MODEL
2019MY~ Niro
EV (DE EV)

NUMBER
234 (Rev 1, 05/13/2021)

TECHNICAL SERVICE BULLETIN

DRIVE UNIT INSPECTION & REPLACEMENT FOR EV MOTOR RUMBLE NOISE

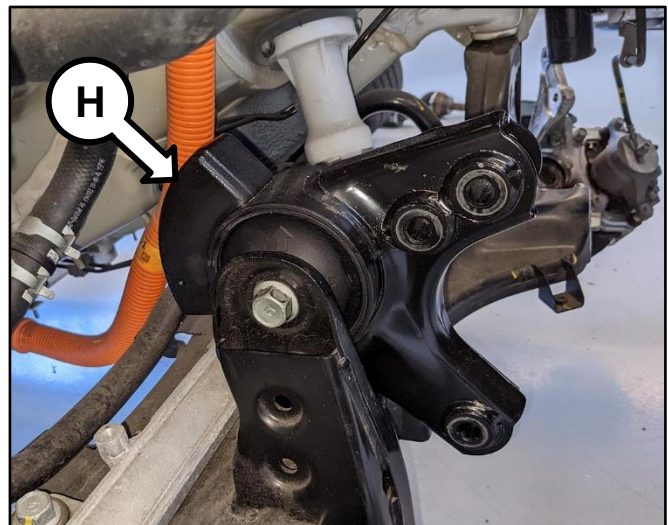
4. Replace the roll mount bracket (H) with the new improved part.

Old Part

New Part

Torque specification:

- Bolt (F): 79.6 – 94.1 lb.ft
(107.9 – 127.5 N.m, 11.0 – 13.0 kgf.m)
- Bolt (G): 47.0 – 61.5 lb.ft
(63.8 – 83.4 N.m, 6.5 – 8.5 kgf.m)

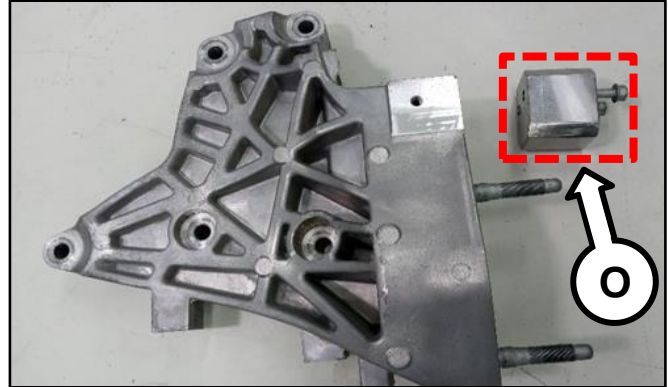
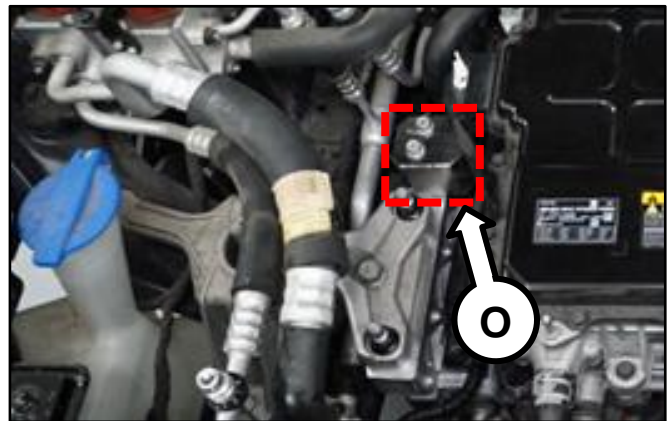
- 9a. Remove the mass (O) from the new motor support bracket.
- 9b. Install the new motor support bracket to the vehicle.

10. Install the mass (O) to the upper side of the new motor support bracket as shown.

Install with the mass protrusion pointing towards the motor.

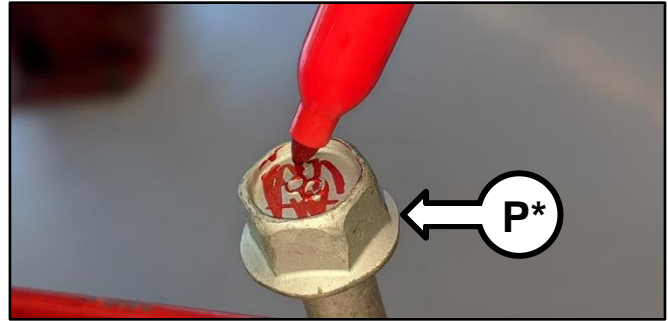
15. Mark the new drive motor and reduction gear connecting bolts (P*) with a red Sharpie (or similar marker) as shown to distinguish them from the old ones.

16. Reinstall the motor and reduction gear using the new bolts in reverse order of removal.
